OBERHEIM ELECTRONICS, INC.
ENGINEERING CHANGE ORDER

402

OB-8

OB-B PROCESSOR BOARD 1679B sheet 2 of 4

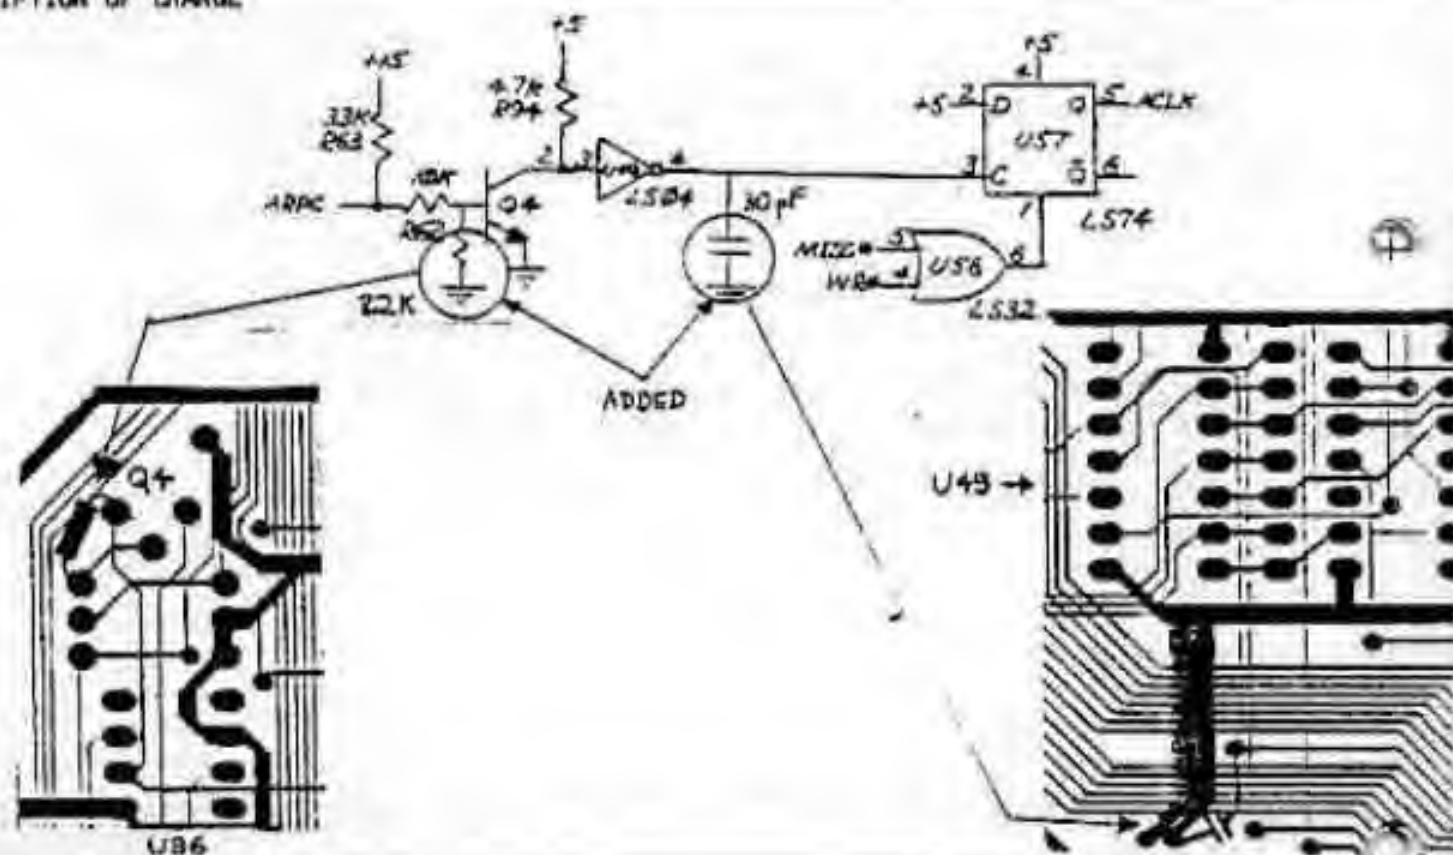
- AVOID MISSING PULSE ON ARPEGGIATOR EXTERNAL CLOCK

DRAWINGS AFFECTED
08-B MOD CAN SCHEMATIC
SHEET 1 OF 1.

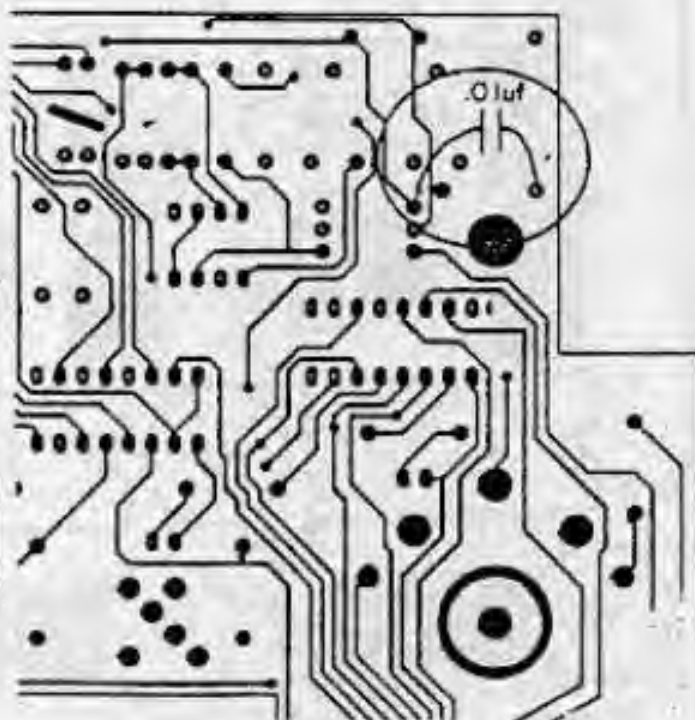
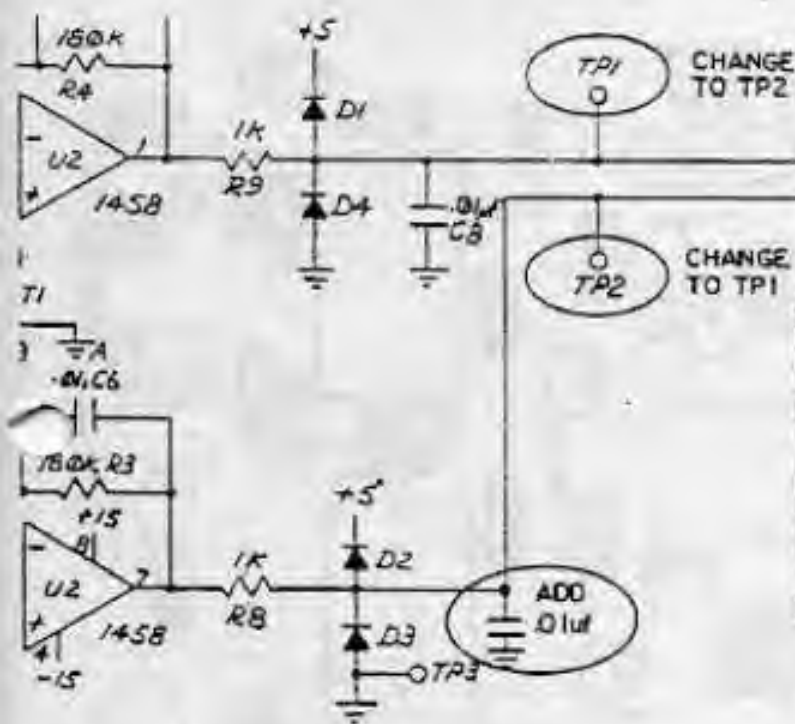
REMOVE NOISE MODULATION FROM
VIBRATO LEVER, AND CORRECT
SCHEMATIC.

1. CHANGE SCHEMATIC AS SHOWN.
2. ADD .01uF CAP (08.153004) FROM GROUND TO TEST POINT (T.P. 2) OF MOD CAN PCB ON 1666 SIDE OF BOARD.

DRAWINGS AFFECTED VOICE BOARD
SCHEMATIC 1682B SHEET 3 OF 3

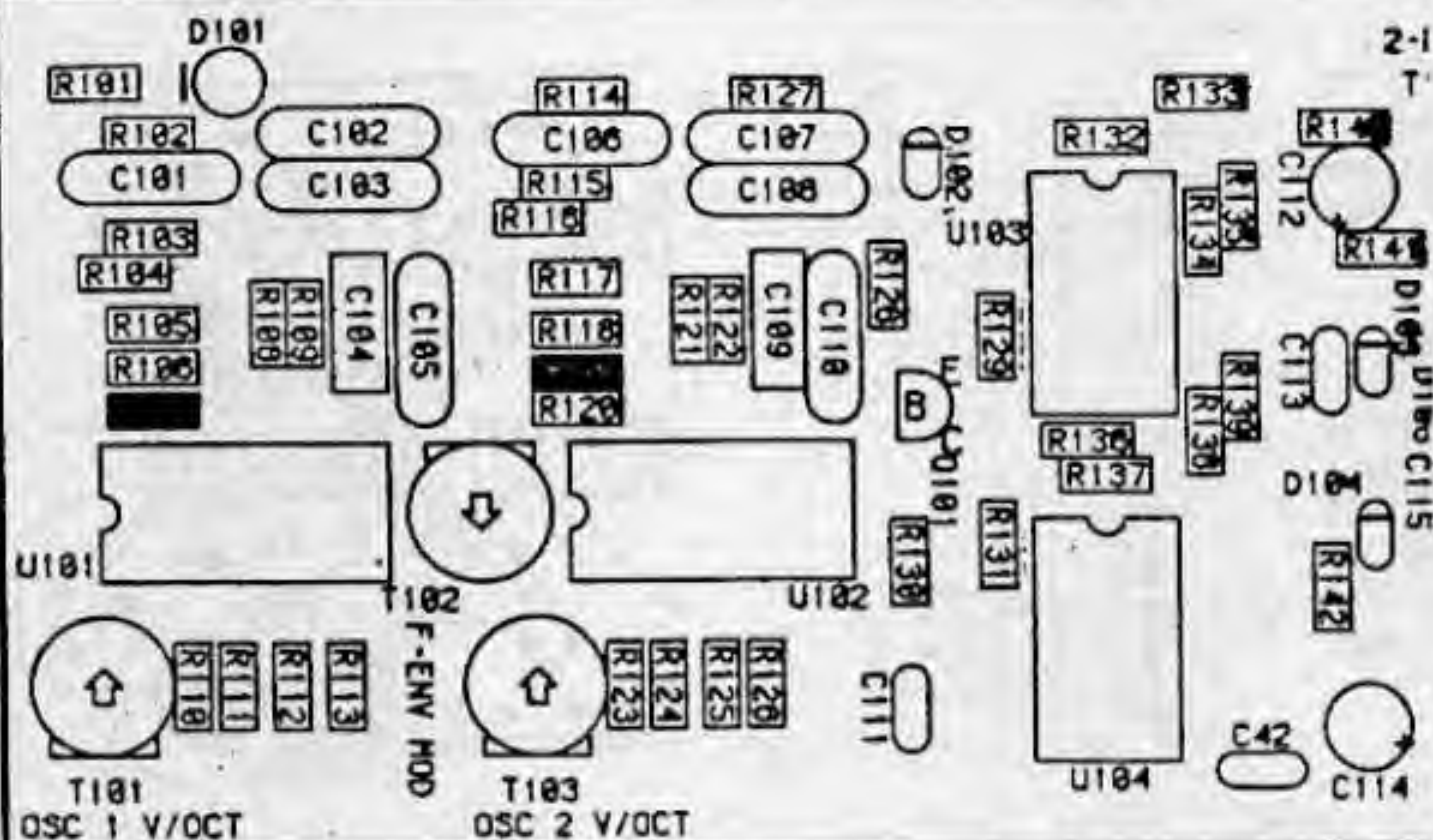
LOWER INITIAL FREQUENCY OF 3340
TO ACCOMMODATE A WIDER RANGE
OF CHARACTERISTIC VARIATIONS ON
THE 3340.

REPLACE RESISTOR RX07 AND RX19 (215K, 1%)
WITH 174K, 1% (08#475520).
